**MASTER DRAINAGE PLAN  
for the  
ATRISCO BUSINESS PARK**

**SEPTEMBER 1992  
REVISED  
MARCH 1993  
OCTOBER 1993  
REDLINE COPY**

*This is an updated version of the Master Drainage Plan for the Atrisco Business Park. Since the time that the March 1993 version was approved, some of the planned facilities have been constructed and the concepts for other facilities have changed. The purpose of this revision is to update the plan to reflect these changes.*

FIGURE NO. 2

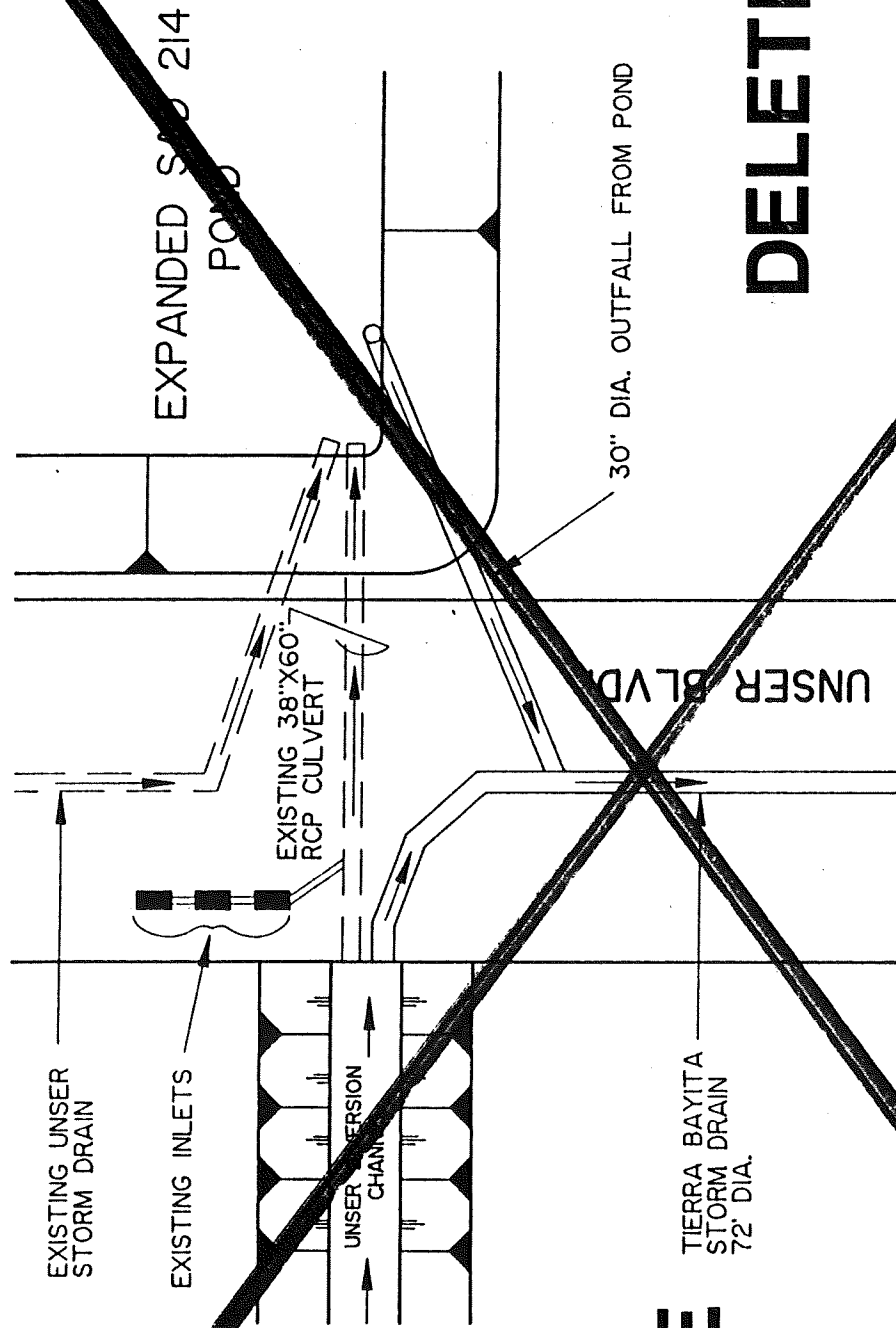
~~Figure 2 – Connection Schematic~~

**DELETE**

**DELETE**

**ATRISCO BUSINESS PARK MASTER DRAINAGE PLAN OVERALL DRAINAGE PLAN FULLY DEVELOPED CONDITION**

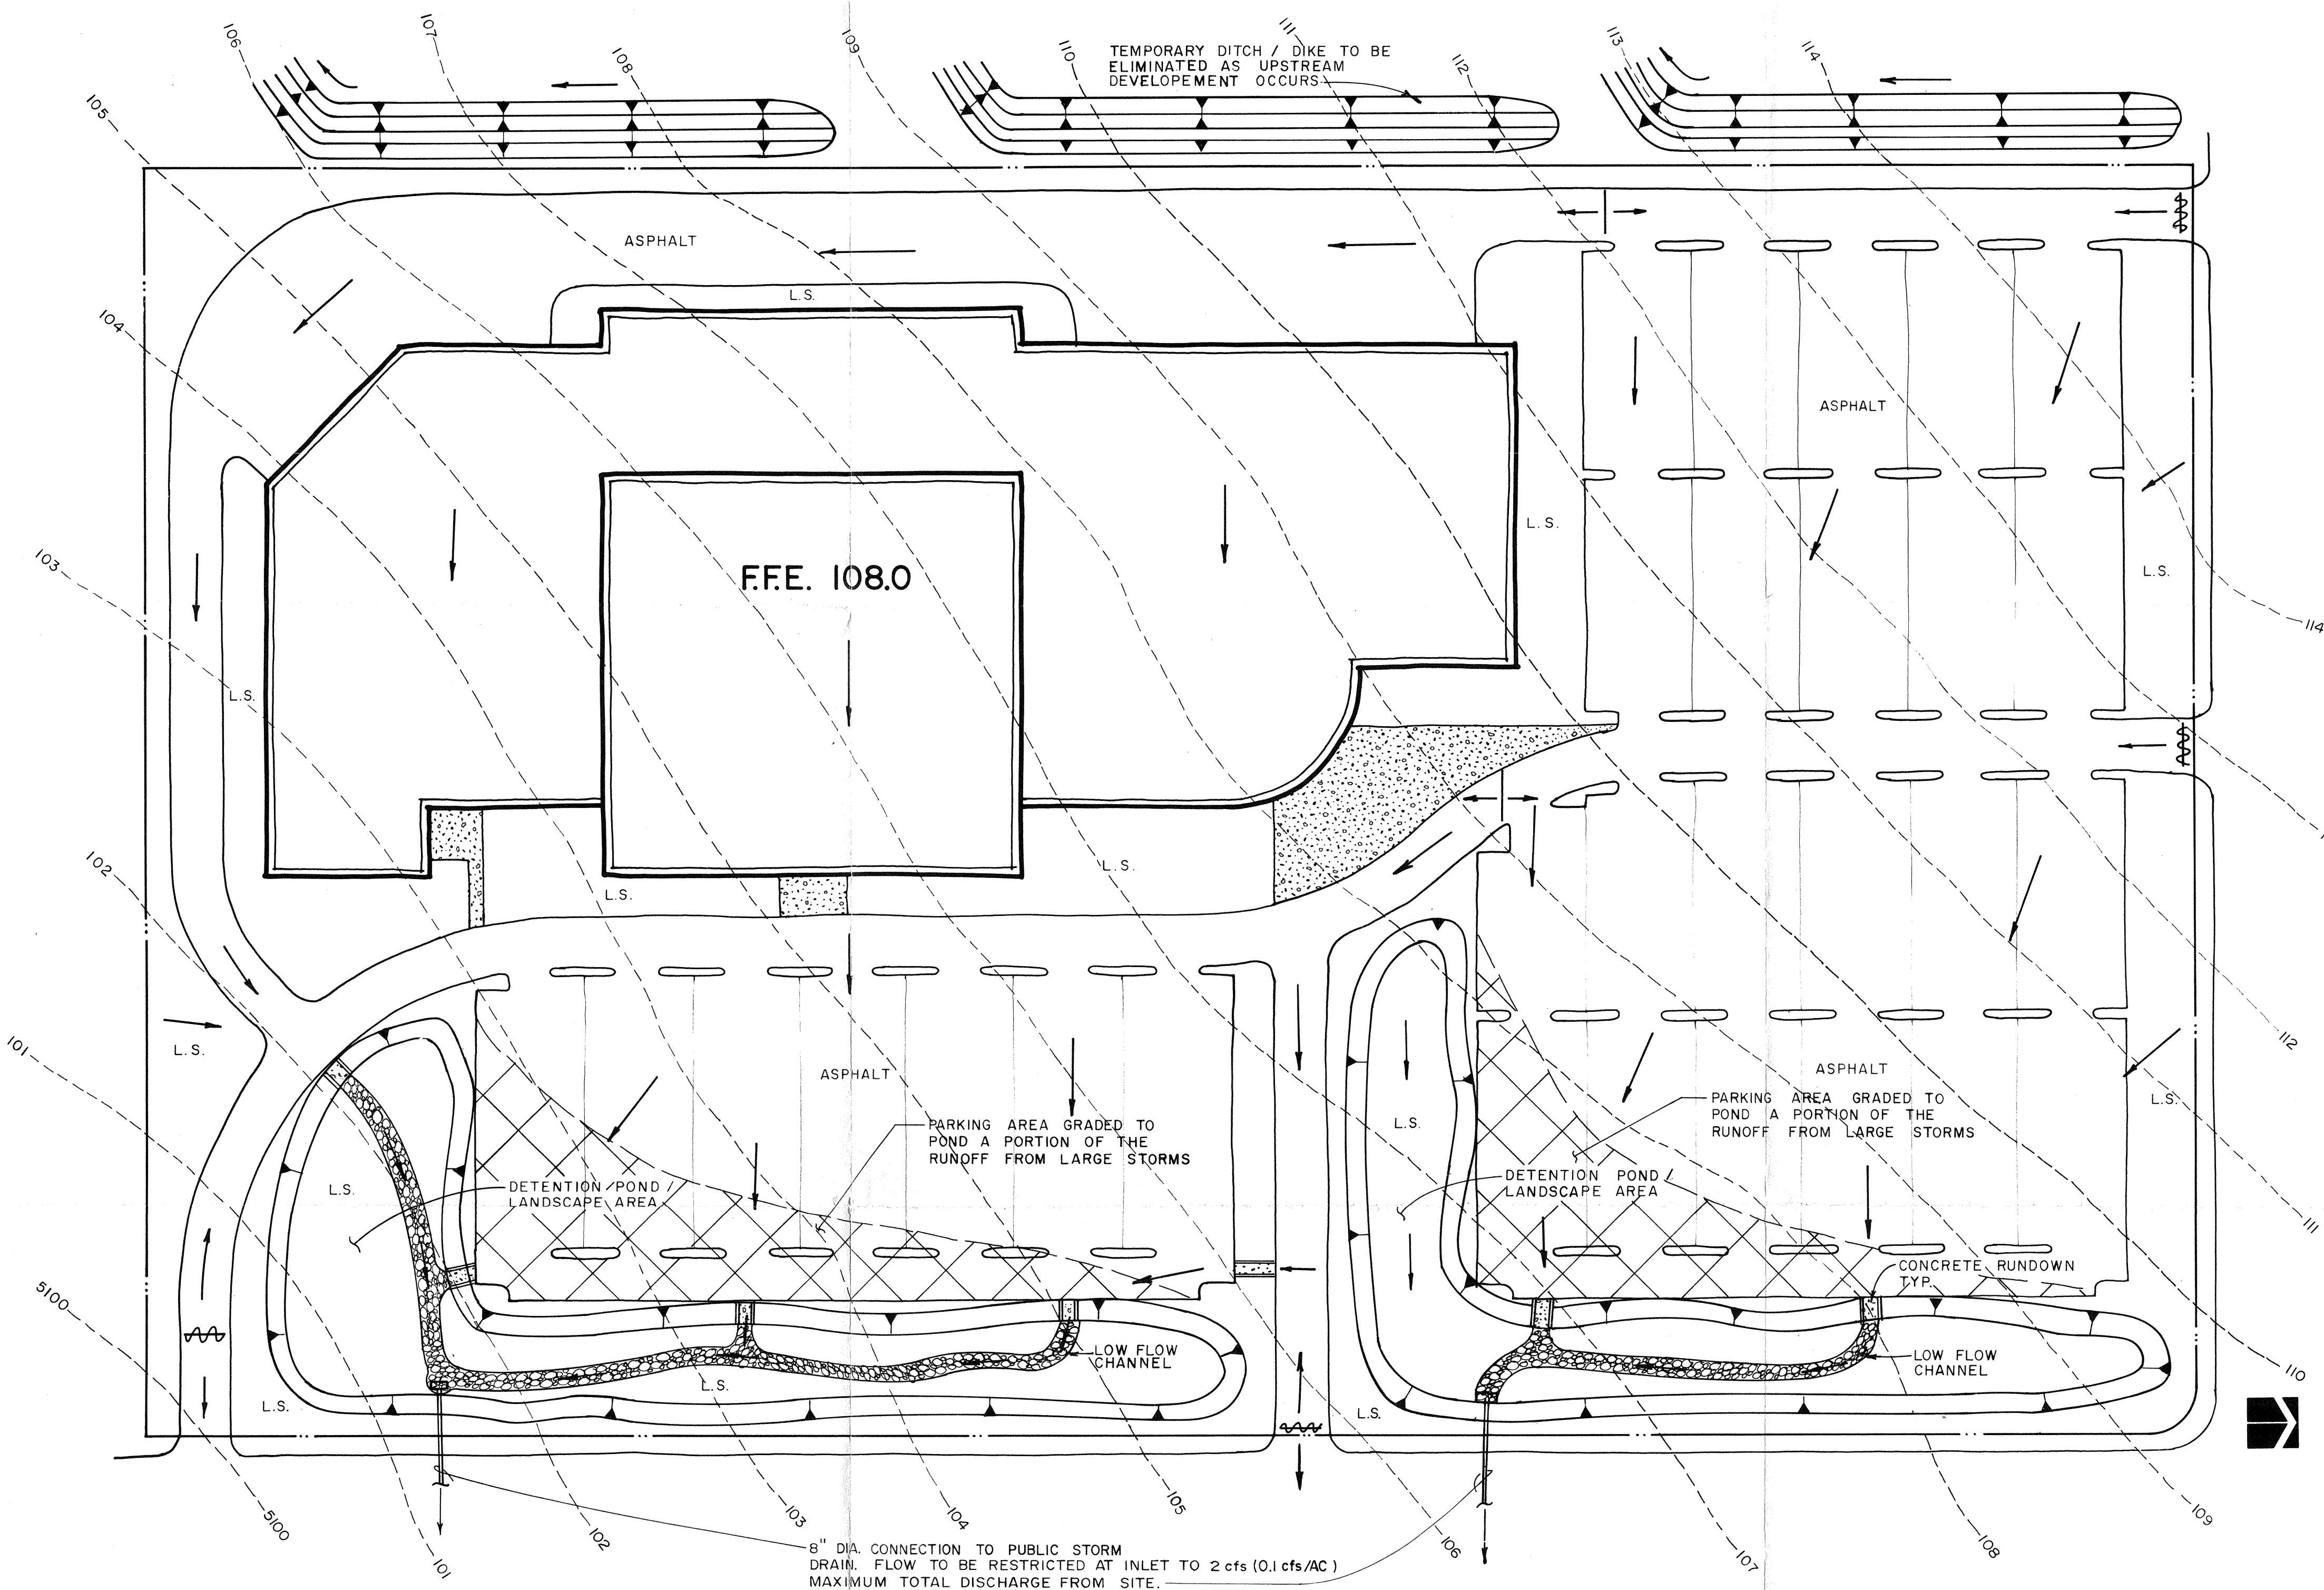
10-93 REVISION  
— REVISED UNSER DIVERSION SYSTEM  
— UP-DATED RUNOFF DATA TO REFLECT THIS CHANGE
